DEPARTMENT OF HAWAIIAN HOME LANDS
STATE OF HAWAII

ADDENDUM NO. 3

**SCATTERED LOT IMPROVEMENTS FOR FIVE
KEAUKAHA LOTS IN TRACT 1**

IFB No.: IFB-16-HHL-014

Figure 1a

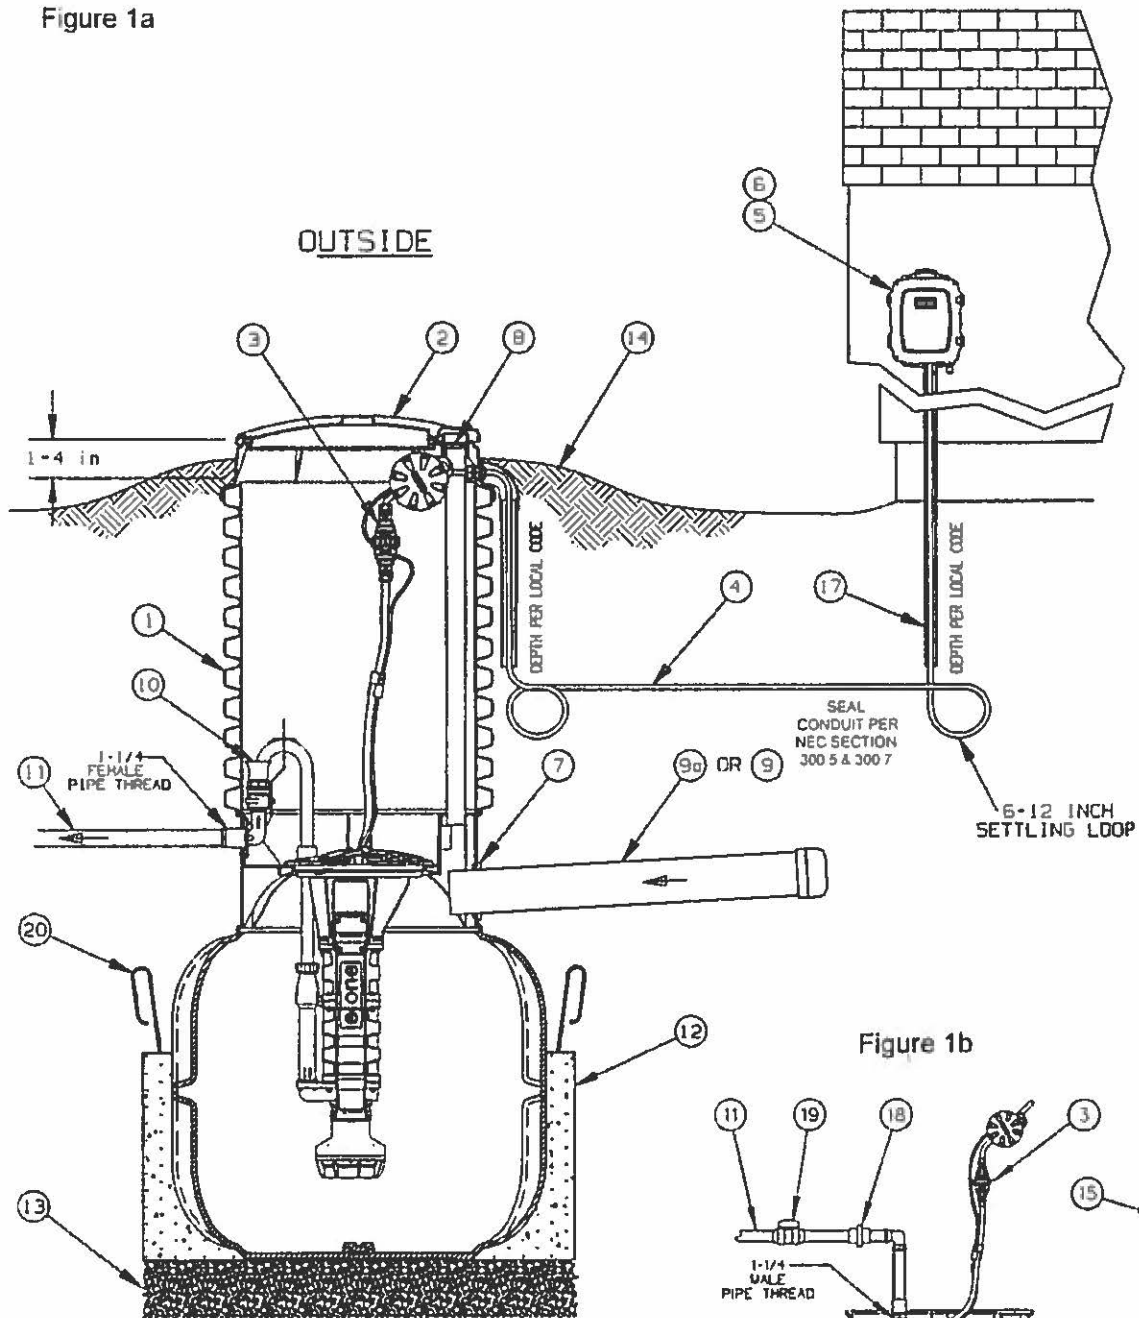
ITEM NO. 2 DETAIL FOR MOUNTING ALARM PANEL NEMA 4X ENCLOSURE

The details for mounting the Alarm Panel Nema 4X Enclosure are attached to **ADDENDUM NO. 3 (June 8, 2016)**.

5. Please provide details for mounting the Alarm Panel Nema 4X Enclosure.

Answer: See attachment for more detail
